Product Change Notification: E-20-008867

PRODUCT GROUP DRAWING FOR 2.8 mm FASTIN-FASTON TAB ( CD: 1670467 )

NAME: PRODUCT GROUP DRAWING FOR 2.8 mm FASTIN-FASTON 19B

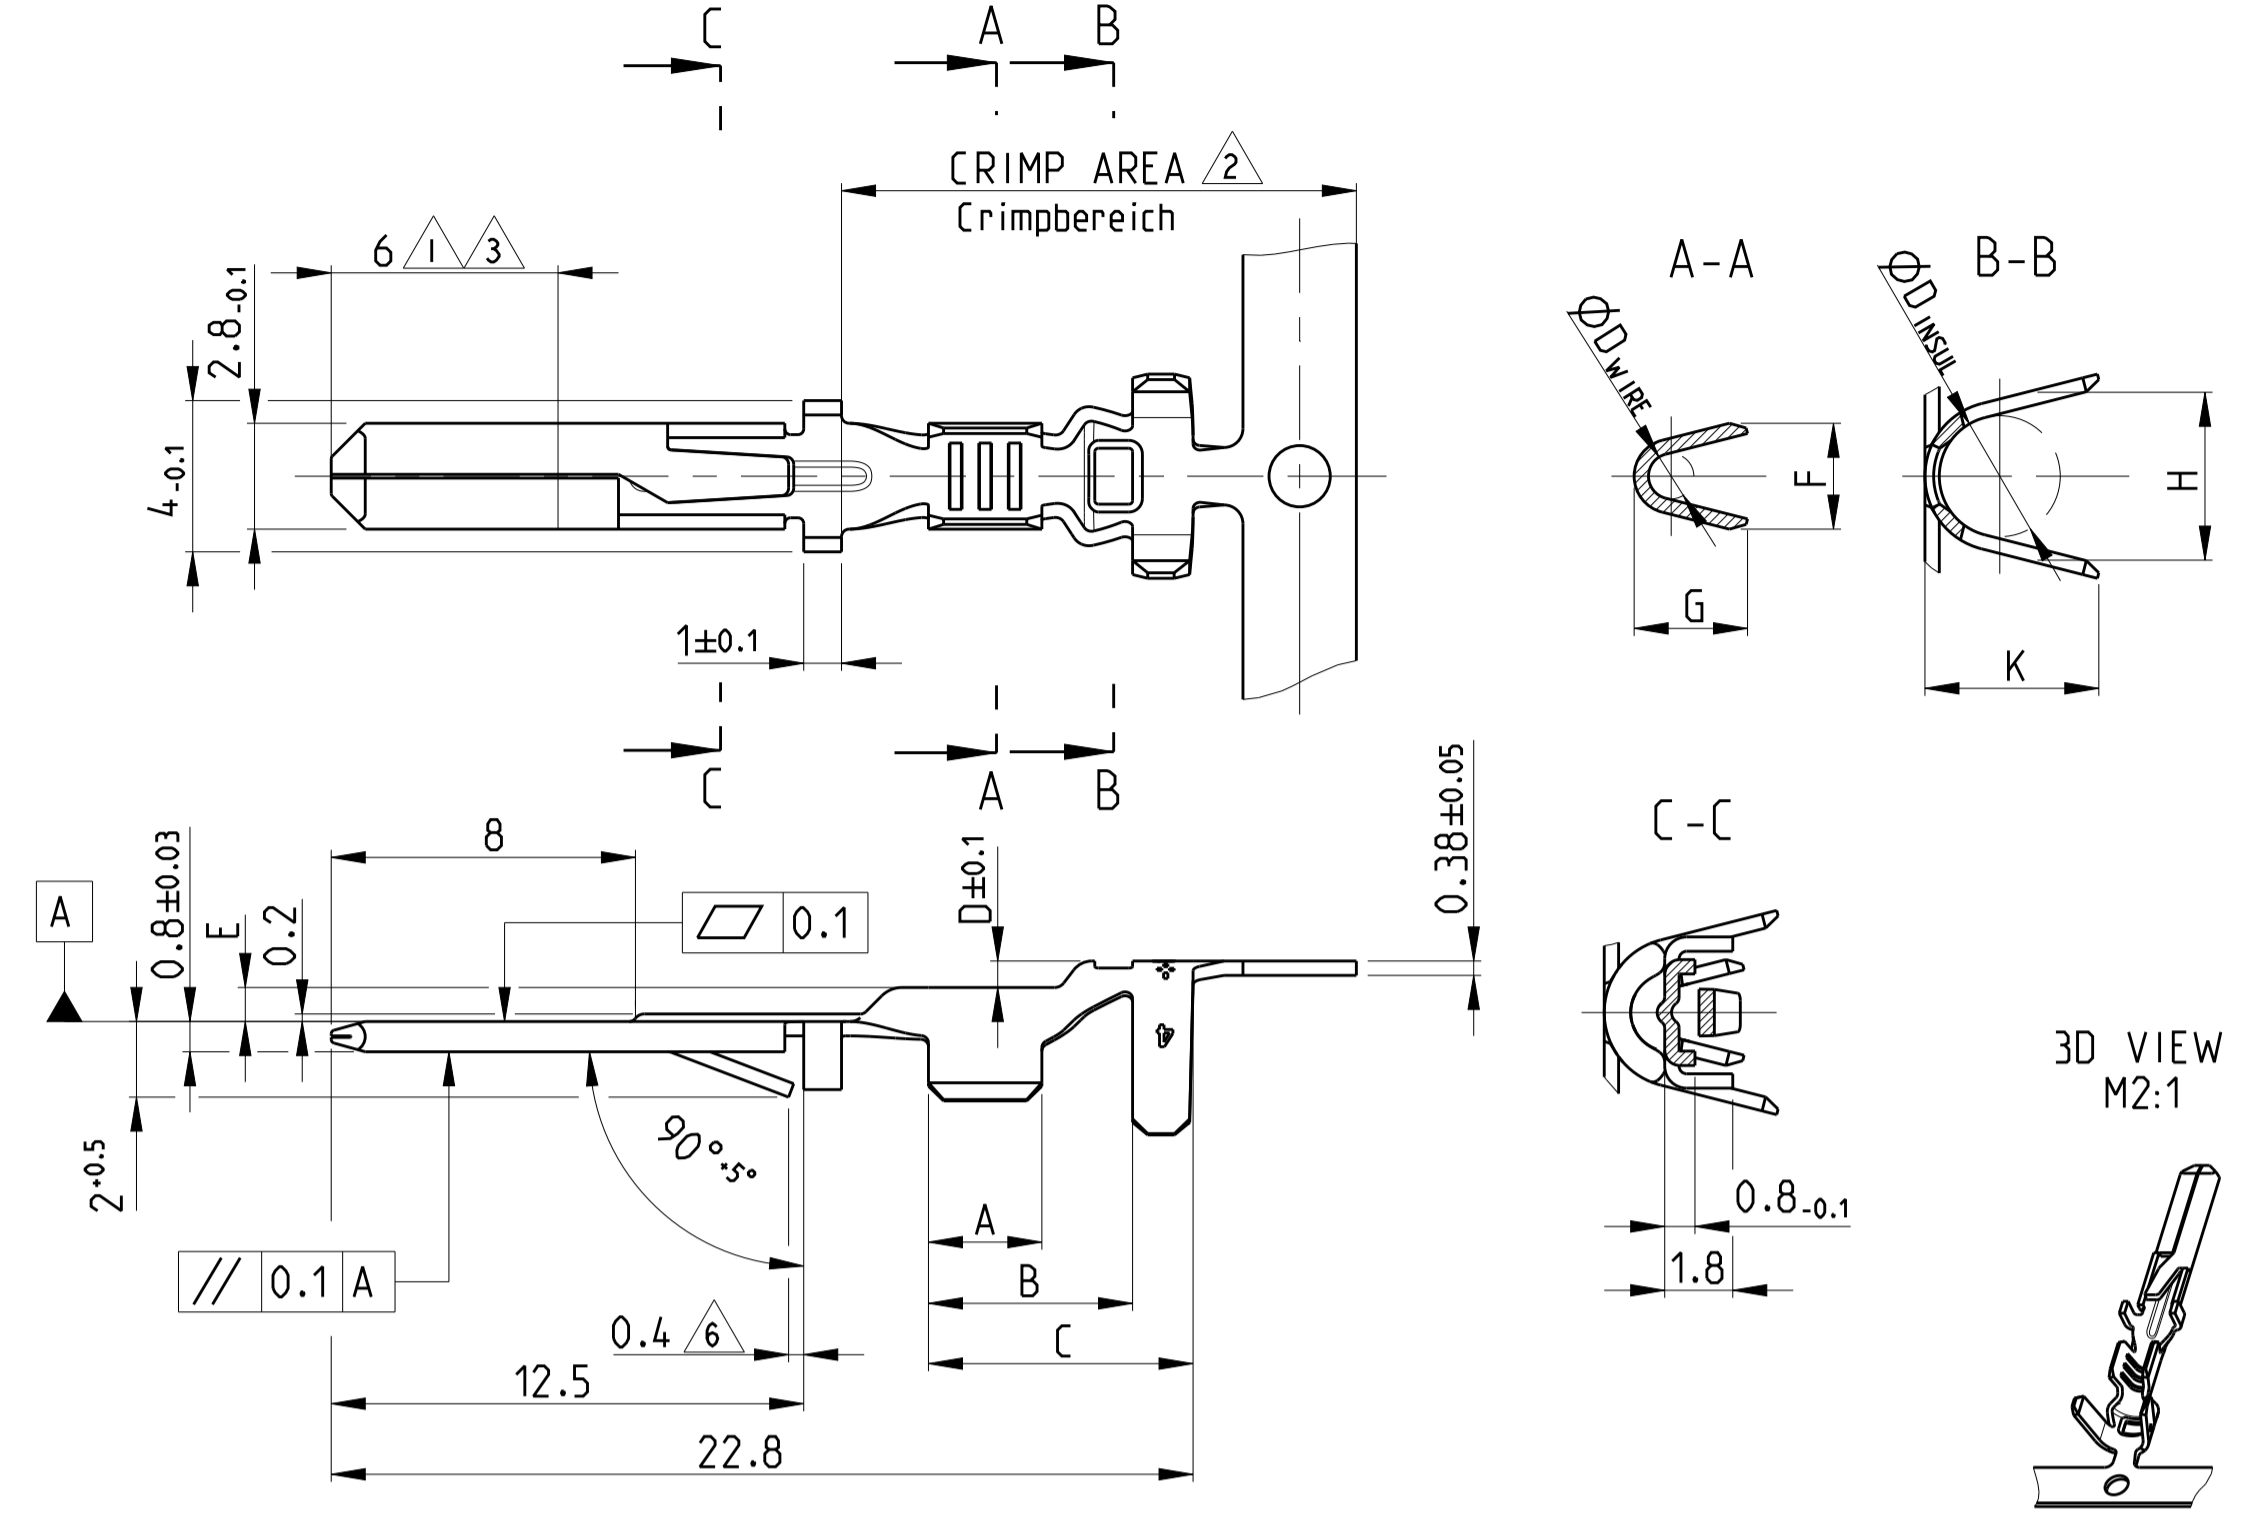
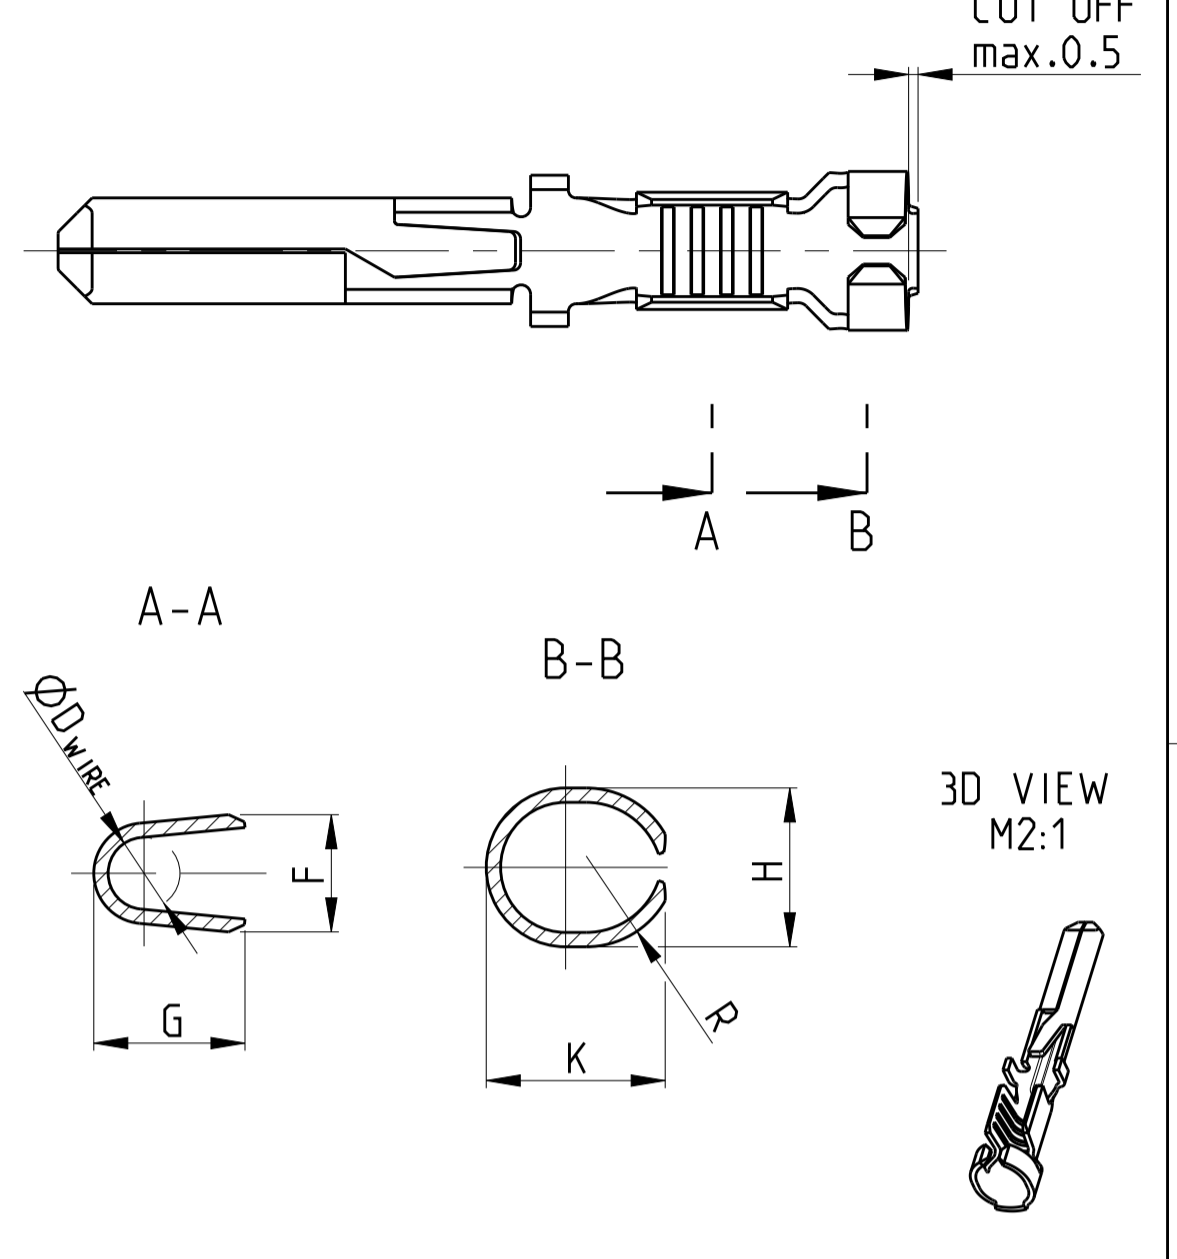
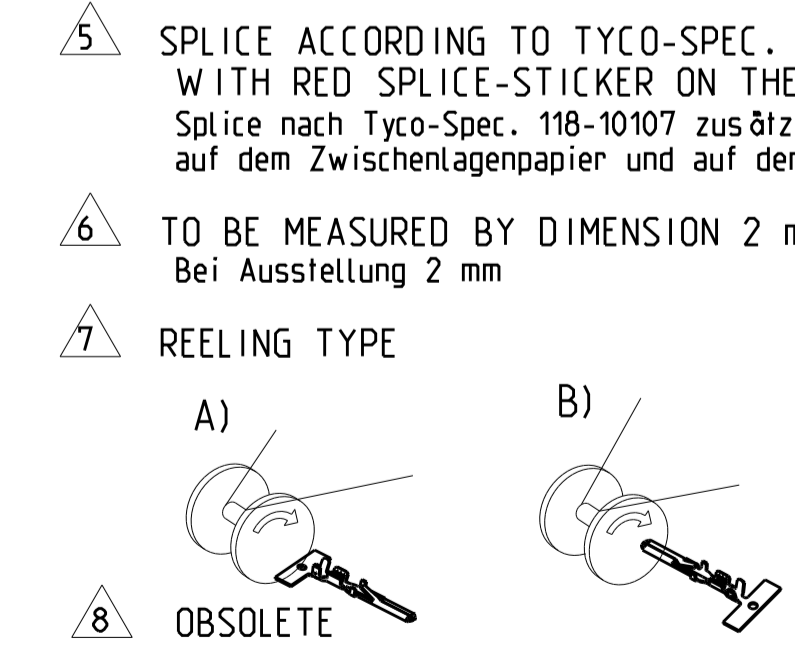
R dimension is changed to reference dimension. The drawings for the listed part numbers have been modified to correct following; 928923, 928931 Before: R 1.8 After: reference
